QUALITY ASSURANCE -- NON-CONFORMANCE REPORT

Report No: NCR-000872

NCR #: ZPMC-0834

Welding	Concrete	Other	
Welding	Curing	Procedural	Bridge No: 34-0006
Joint fit-up	Coating	Other	Component: OBG Bike path. (Lift 8E)
Procedural	Procedural	Description:

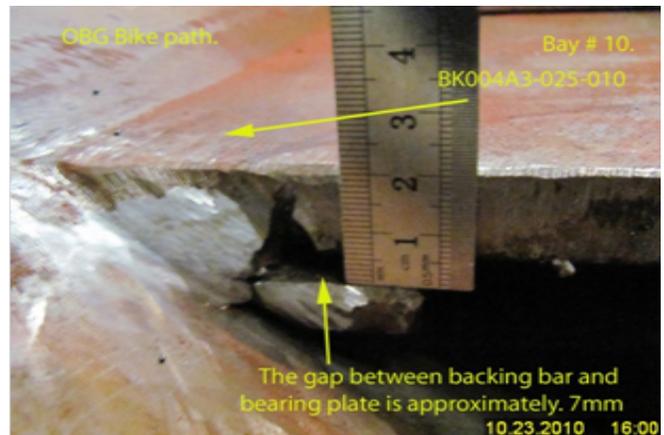
During the Caltrans Quality Assurance (QA) in-process observations of the fabrication of OBG Bike path plate BK004A-025 (Lift 8E), this QA Inspector discovered the following issue:

- Steel backing was not properly placed and held in intimate contact with the base metal.
- The gap between steel backing and bearing stiffener plate is observed approximately 7mm.
- The weld is Complete Joint Penetration (CJP) with steel backing joining the Bearing Plate and End Plate (side plate) of bike path.
- The weld is identified as: BK004A3-025-010.
- The member is located in bay #10.
- The Notice of Witness Inspection Number (NWIT) is 07078. ZPMC had inspected this weld prior to submitting the NWIT.

-AWS D1.5 2002, Section 3.13.5: "Steel backing shall be placed and held in intimate contact with the base metal. The maximum gap between steel backing and the base metal at the weld root shall be 2 mm."

-AWS D1.5 2002, Section 3.13.2: "Groove welds made with the use of steel backing shall have the weld metal thoroughly fused with the backing. Steel backing shall be continuous for the full length of each weld made with backing."

NDT and VT have been performed on the weld area where the backing bar was removed and the results are acceptable. To prevent future occurrences, the inspector fit up inspection will verify that the backing bar is tacked sufficiently to ensure that it will remain in place during welding. ZPMC has written an internal NCR to this effect to inform their inspectors.

The proposed resolution is acceptable. This NCR is closed.

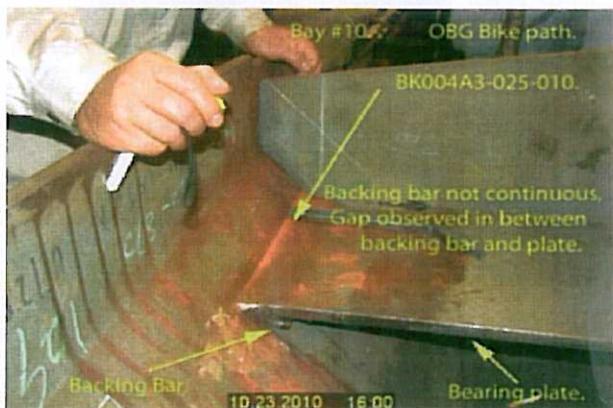
During the Caltrans Quality Assurance (QA) in-process observations of the fabrication of OBG Bike path plate BK004A-025 (Lift 8E), this QA Inspector discovered the following issue:

- Steel backing was not properly placed and held in intimate contact with the base metal.
- The gap between steel backing and bearing stiffener plate is observed approximately 7mm.
- The weld is Complete Joint Penetration (CJP) with steel backing joining the Bearing Plate and End Plate (side plate) of bike path.
- The weld is identified as: BK004A3-025-010.
- The member is located in-bay #10.
- The Notice of Witness Inspection Number (NWIT) is 07078. ZPMC had inspected this weld prior to submitting the NWIT.

-AWS D1.5 2002, Section 3.13.5: "Steel backing shall be placed and held in intimate contact with the base metal. The maximum gap between steel backing and the base metal at the weld root shall be 2 mm."

-AWS D1.5 2002, Section 3.13.2: "Groove welds made with the use of steel backing shall have the weld metal thoroughly fused with the backing. Steel backing shall be continuous for the full length of each weld made with backing."

Contractor will perform NDT and VT to prove the weld area where the backing bar was removed, and was not adversely affected. Contractor ensure the backing bars are tacked sufficiently in fit-up to ensure the backing bars are in tack during welding. Internal NCR will be issued to the inspectors.

NDT and VT were performed on the weld area where the backing bar was removed, and the results are acceptable. Contractor issued the internal NCR to the inspector.
